REQUESTED HYDROLOGICAL INFORMATION

As requested in the e-mail from Saskia Ball (at the Canterbury Regional Council) to yourself (dated 4 August 2016) this letter provides additional information related to the Klondyke Storage Proposal - Hydrology Assessment. We understand that the information requested is not part of the formal request for further information but would aid in making the application clearer to understand. This letter answers the hydrology questions in the same order as they are expressed in Ms Ball's e-mail.

RANGITATA DIVERSION RACE LIMITED - KLONDYKE STORAGE

Example Hydrographs Natural Scale

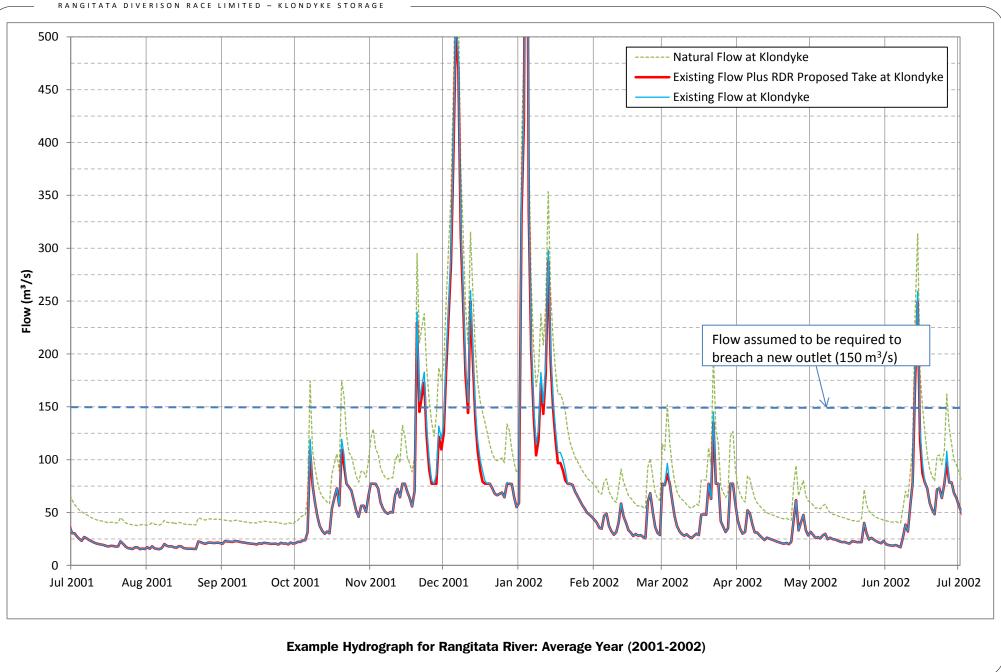
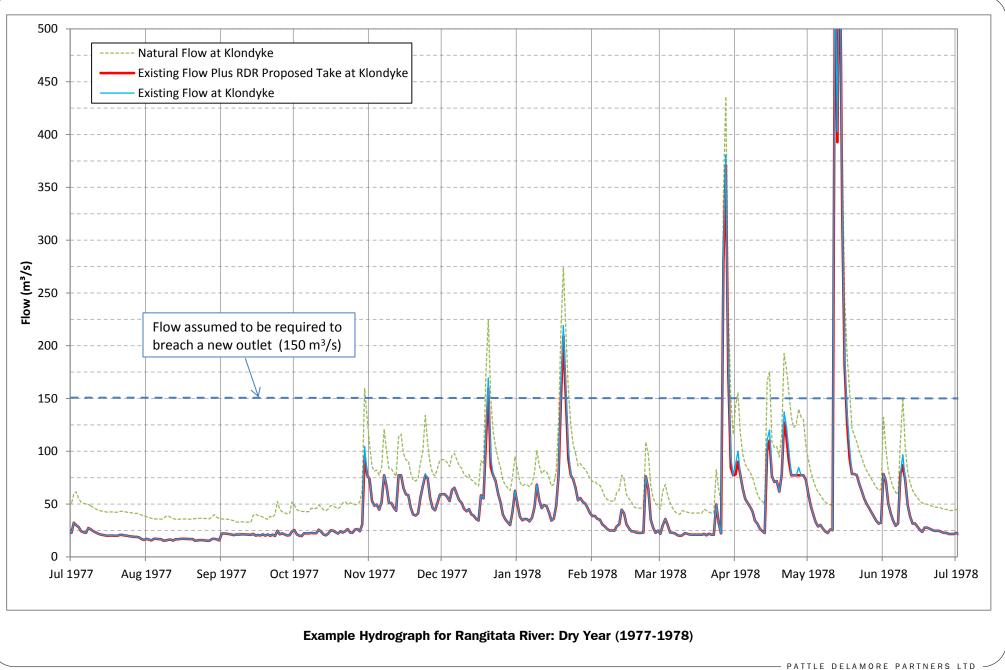
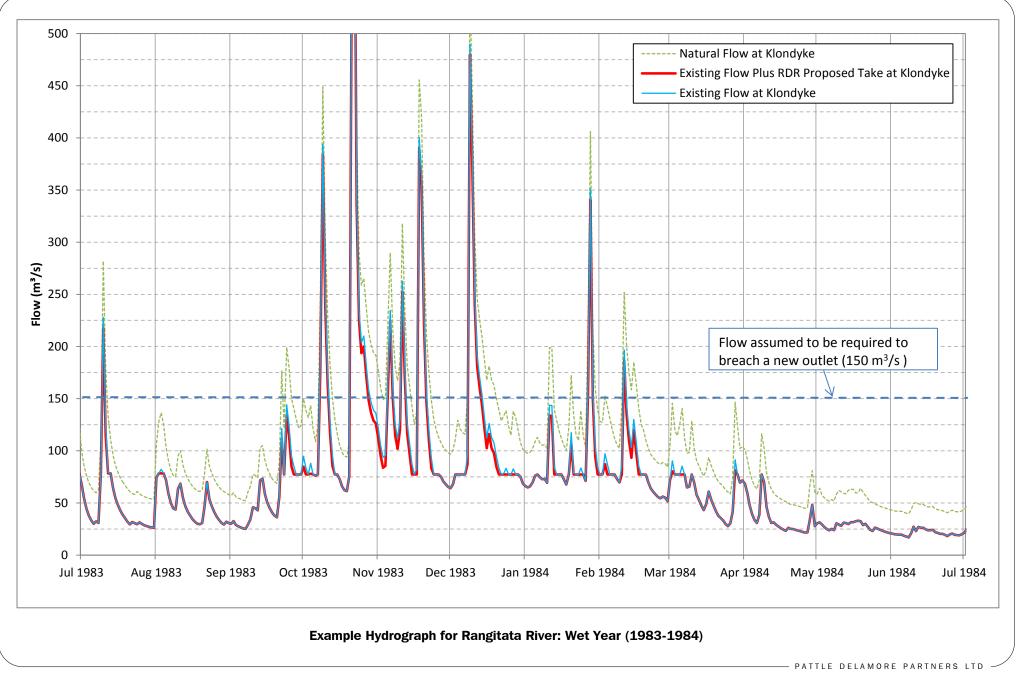
• Question 2: The hydrographs in Appendix H of the hydrology assessment are in the log scale – it would be good to retain these but also to provide a graph of the effects of the proposal at a natural scale as well (maybe truncated at a maximum flow of $500 \text{ m}^3/\text{s}$).

Answer: Hydrographs with a natural scale (truncated at a maximum flow of 500 m³/s) are attached to this letter (Attachment 1).

Flow Duration Curves Natural Scale

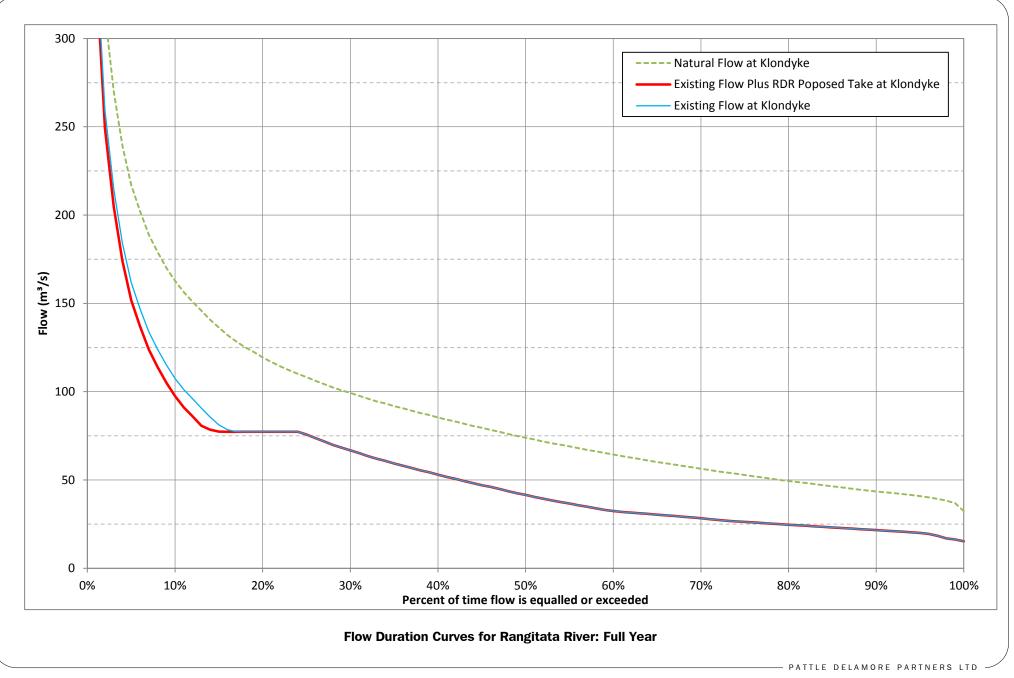
• Question 3: The flow distribution curves in Appendix I of the hydrology assessment are also in the log scale – same as above, it would be good to retain these but also to provide a graph of the effects at a natural scale as well.

Answer: Flow duration curves with a natural scale (truncated at a maximum flow of $300 \text{ m}^3/\text{s}$) are attached to this letter (attachment 2).

Annual flow plots between 1 November and 30 April

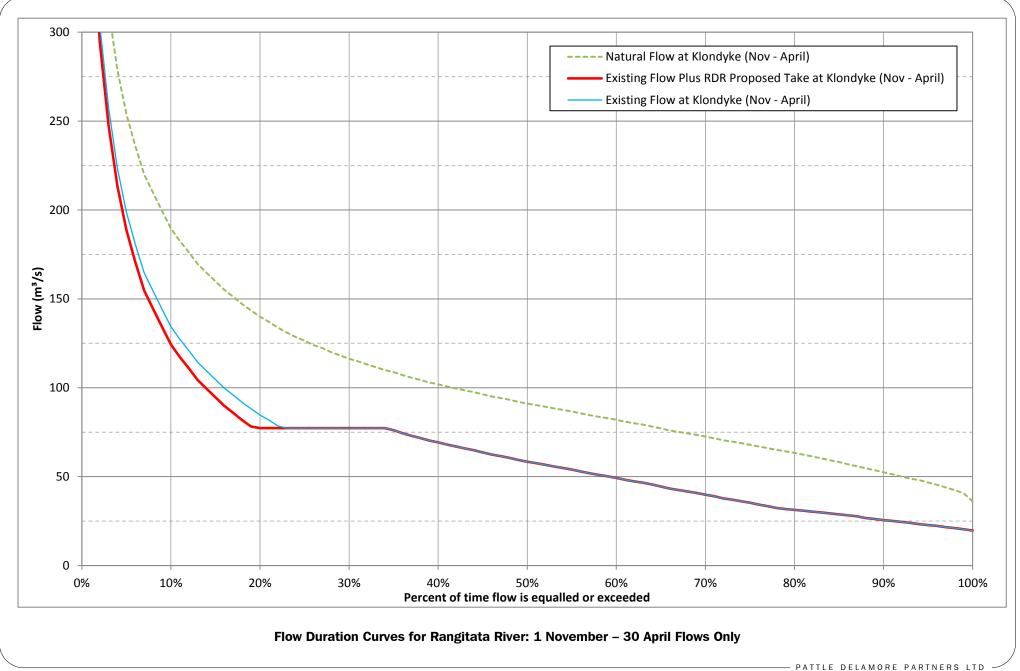
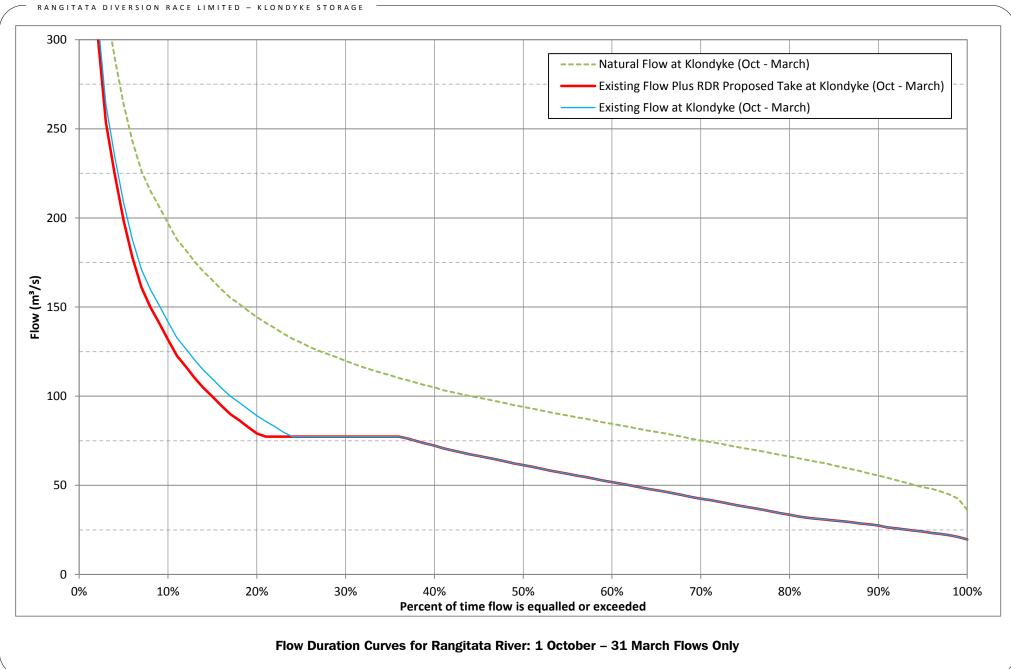
• Question 4: Please provide annual flow plots from 1 November to 30 April to show when the FRE3 would be absent (requires over plots of natural, current and proposal). This would allow an assessment of effects of the proposal upon the duration of periods between FRE3 events.

Answer: Annual flow plots from 1 November to 30 April are provided in attachment 3 for the three example years (average, wet and dry). These plots include a line indicating a flow of three times the natural median (222 m³/s). We note that the relevant comparison for this application is between the existing and proposed state. In these example years there is no difference in the number of FRE3 events over the period 1 November to 30 April between the existing and proposed state. One additional hydrograph (November 1981 – April 1982) is added to show one year where there is a change in the number of events exceeding three times the median flow. In that year the modelled flood peak in November for the existing state is 222.4 m³/s which is reduced to 212.4 m³/s under the proposal. The duration of time between events exceeding three times the median flow is quantified in Appendix J of the hydrology AEE (mean and maximum accrual time) and further comments on the significance of these changes as a result of the proposal on the risk of nuisance periphyton growth are provided in the Water Quality and Aquatic Ecology Assessment (Ryder Consulting Ltd, July 2016).
